St Luke's Grammar School:

**Resident
submissions
and evidence
for rejecting
any increses
in student
numbers.**

A proposal for Northern Beaches Council, 30 January 2019

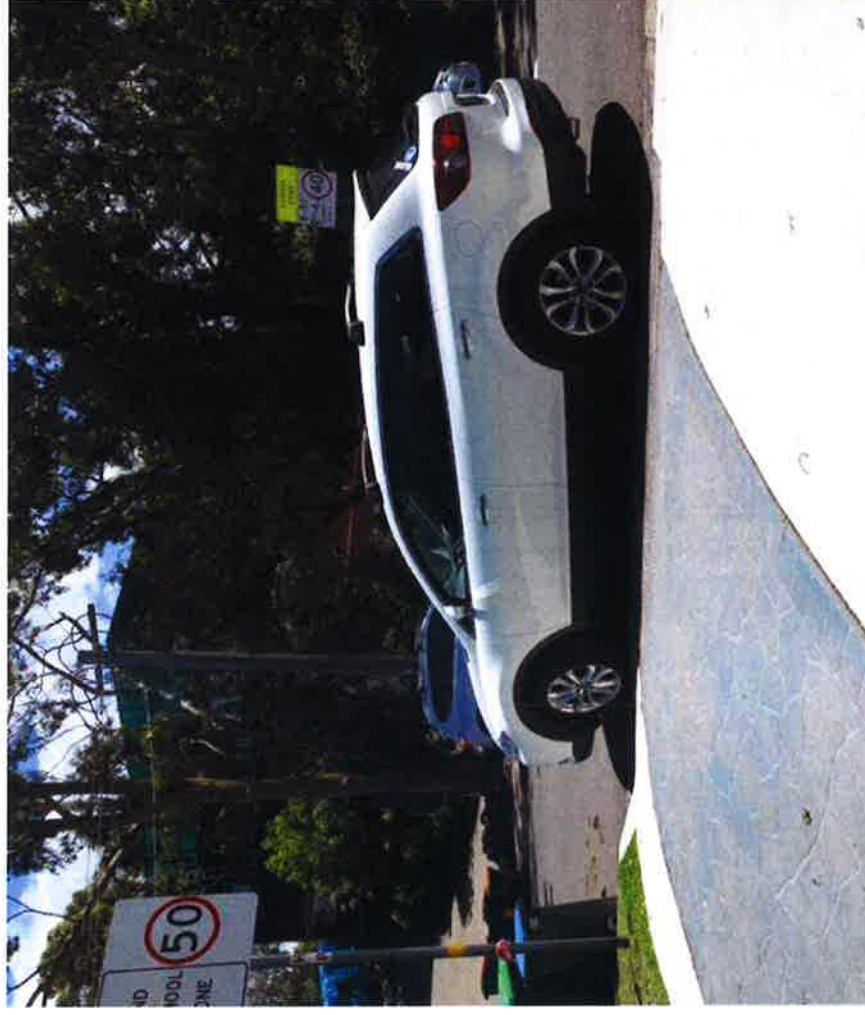
- Page 15 & 16 – 2.5 The arrival and departure of students via the Headland Road drop off/pick up zone is encouraged to be used parents /carers.

This statement is False (refer to photographic evidence on different days)

Very many parents drop off children in Headland Road using our driveways and pulling over in No Stopping zones. The below images clearly confirm parking infringements in Headland Road – intruding parking over driveway edge and a parent's car parked, minus its driver, parked across my driveway at 209 Headland Road.

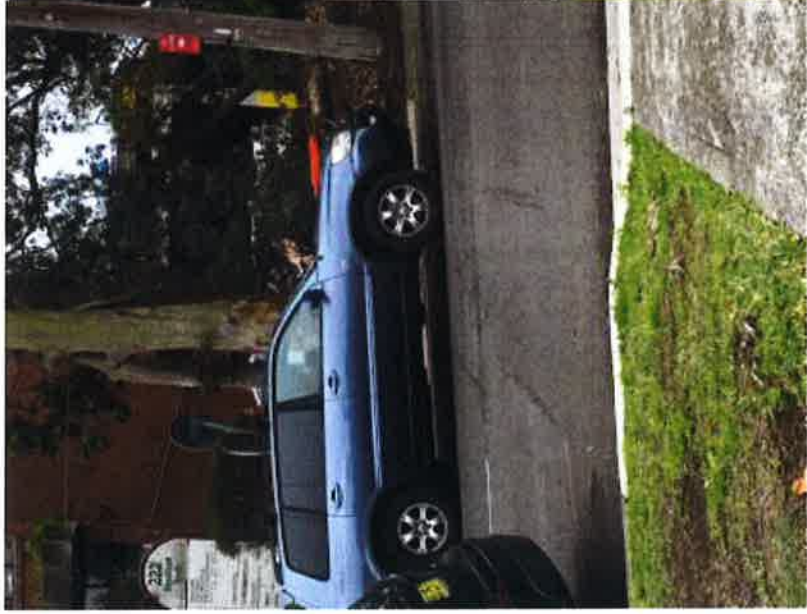
This woman is a repeat offender – just about every day.

So parents supposedly obey all traffic rules and regulations when it comes to dropping off/picking up their children. **NOT TRUE.** Photographic evidence proves they do not obey the road rules, let alone "No Stopping" signs from the top side of the driveway of 222 Headland Road down to 226 Headland Road. Parents are consistently stopping and sitting in their cars in this zone. Why isn't the Ranger patrolling at these times of day.

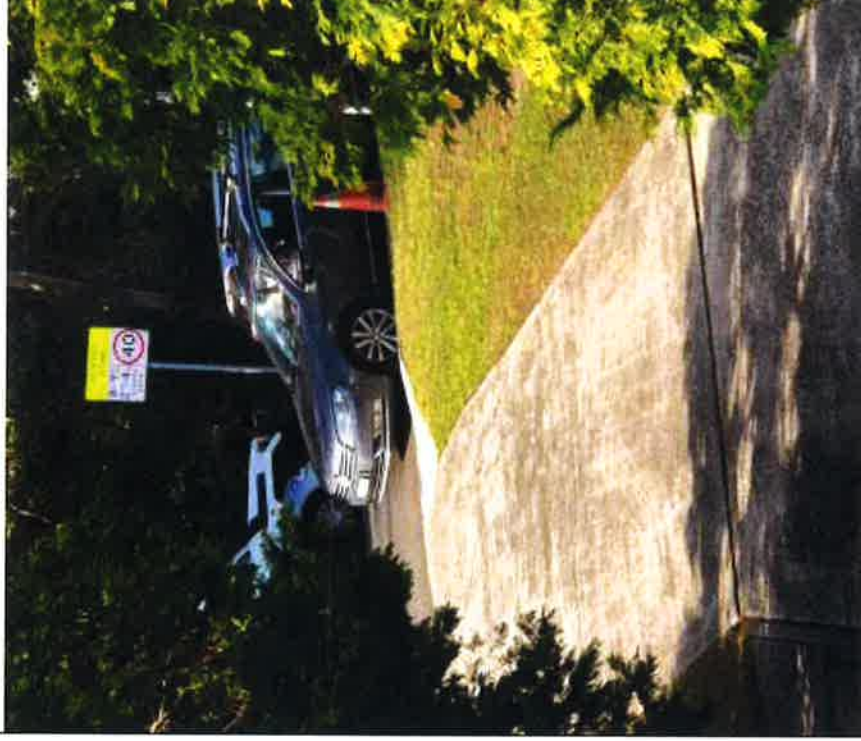
This car is parked illegally over our driveway, 211 Headland Rd. This space is not a legal sized space but the Council refuses to install a "No Parking/Stopping" sign. Try getting out of the driveway when a car is parked there illegally – impossible.

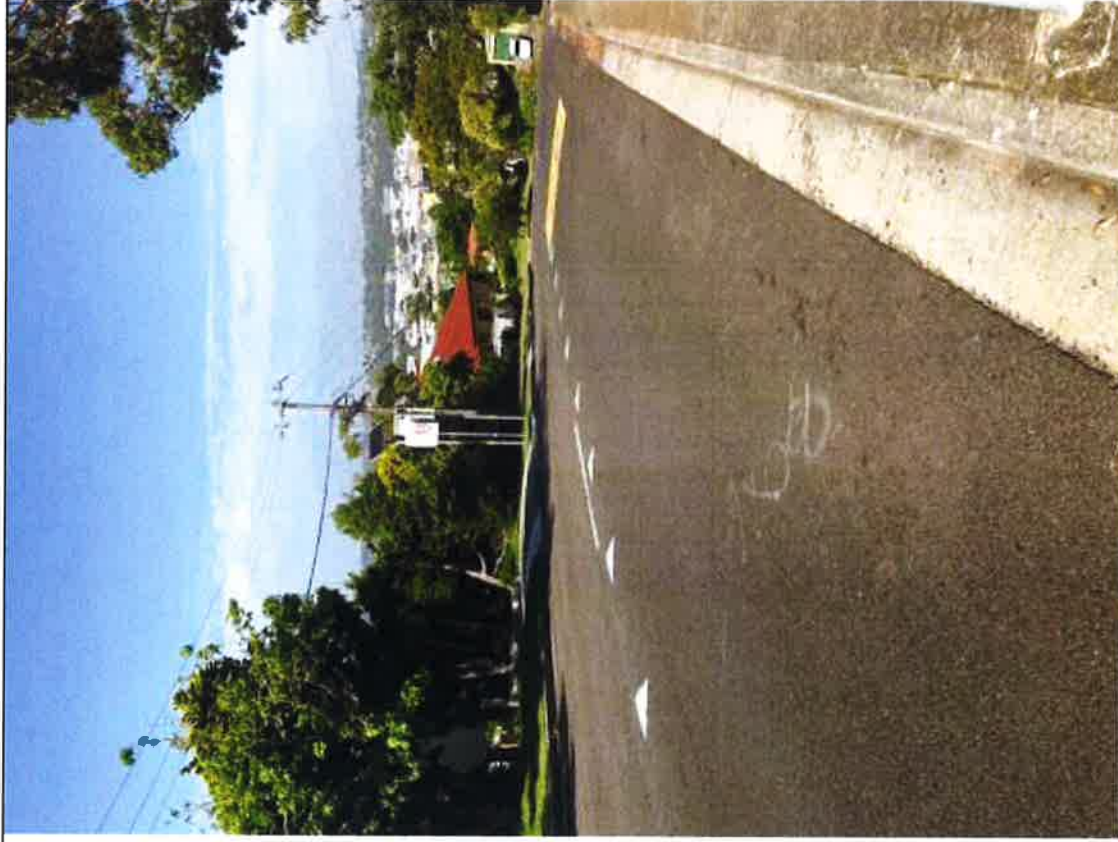
The Principal claims that the P-Plate drivers parked in the street are not associated with the school. What utter rubbish. The photos show that not one p-plater is parked in the street during the school holidays. Headland Road is clear.

These photos were taken on Wednesday, 16 January 2019 just after 8.00 am.

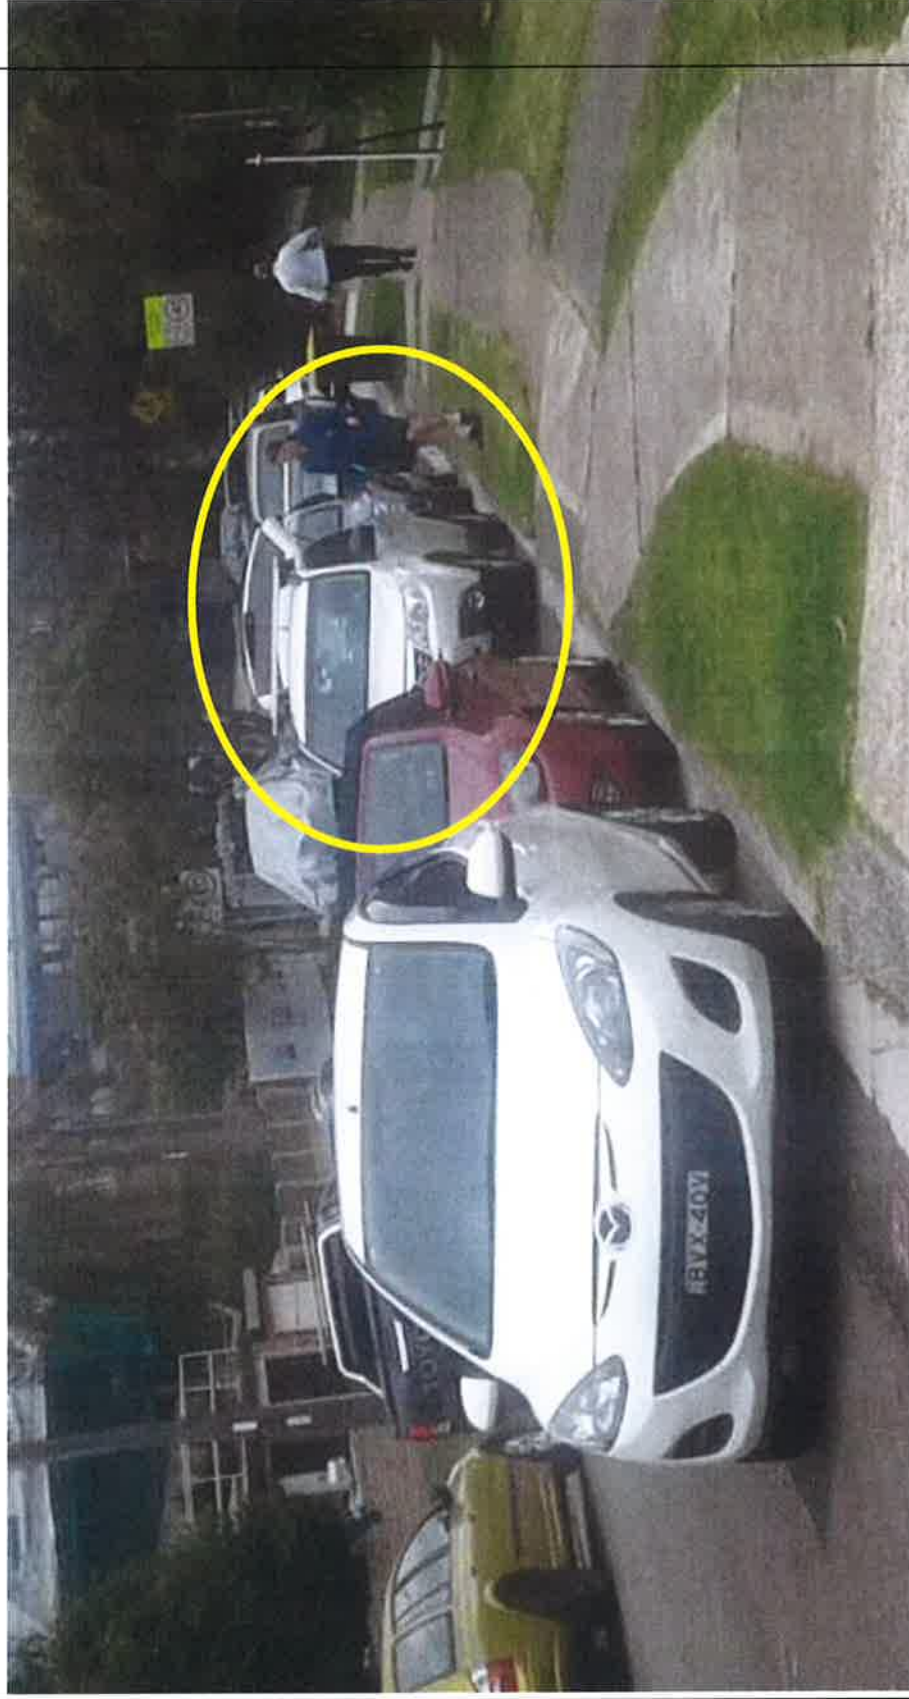
Statement by School –
“Significantly, the school no longer allows parents to park their car in Tango Avenue, get out of the car and go into the school to collect their child/children.”

This statement is FALSE with a number of examples of parents parking along Tango Ave, avoiding the allocated pick-up/drop-off zone. These pictures 100-300metres from the school boundary to demonstrate the issues residents face each school day on the local road system
